## Submittal #237413-3.2 - Make up Air Units (MAU) 237413 - Commercial Packaged Rooftop Units

# National Account MAU Rev3 Submittal

**Job Name:**  
Web Services LCK062 Bldg B Shell

Tag: MAU-1

**Unit Electrical Data**

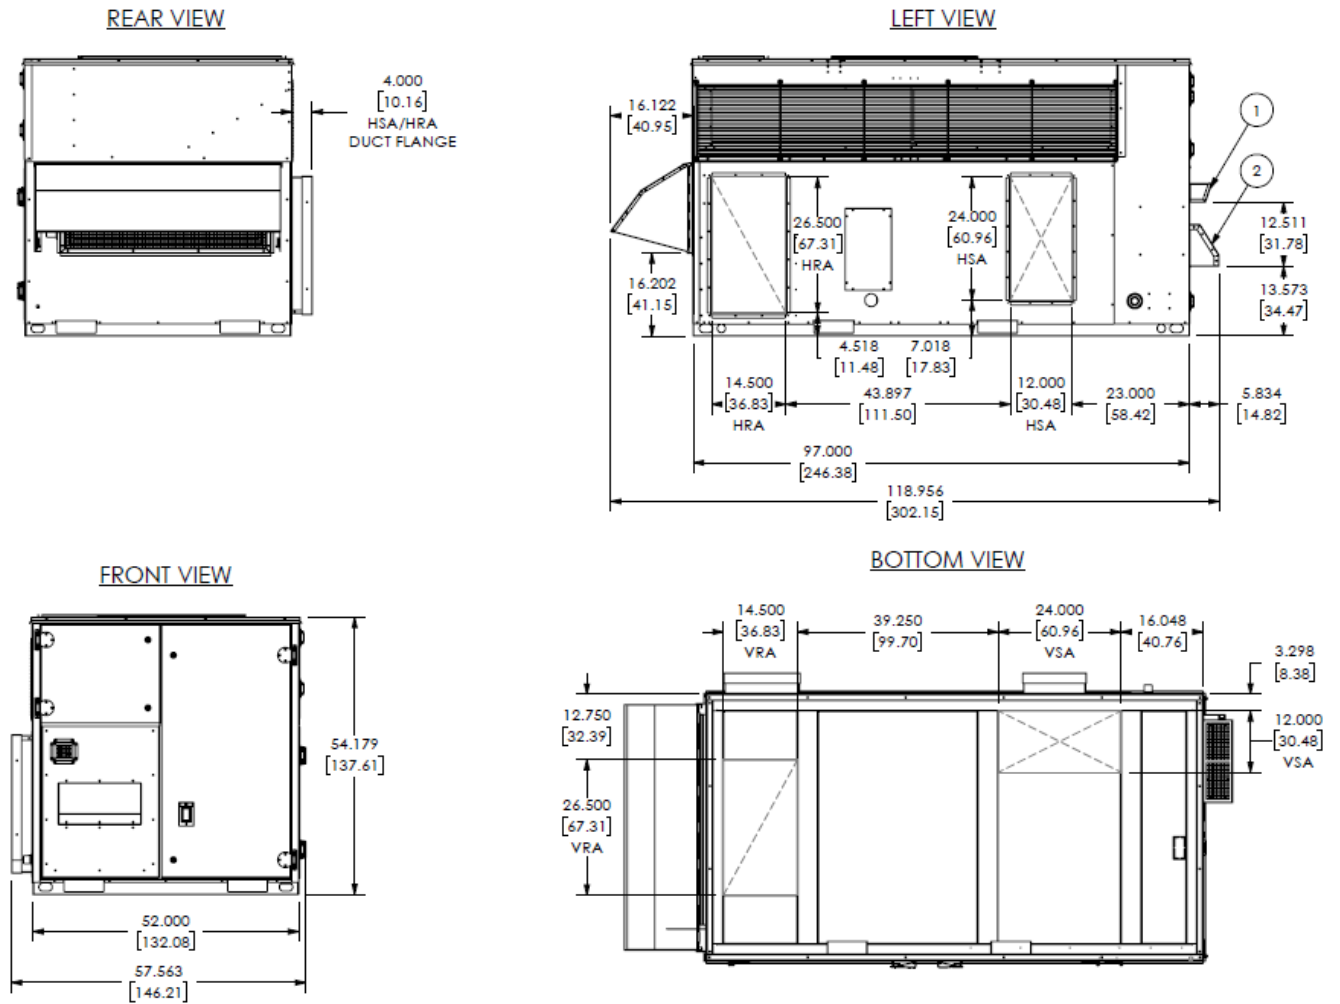
Scheduled FLA is 26 A. Electrical to review.  
This is an acceptable discrepancy, and has been propagated. -TAO

Scheduled MCA is 33 A. Electrical to review.  
This is an acceptable discrepancy, and has been propagated. -TAO
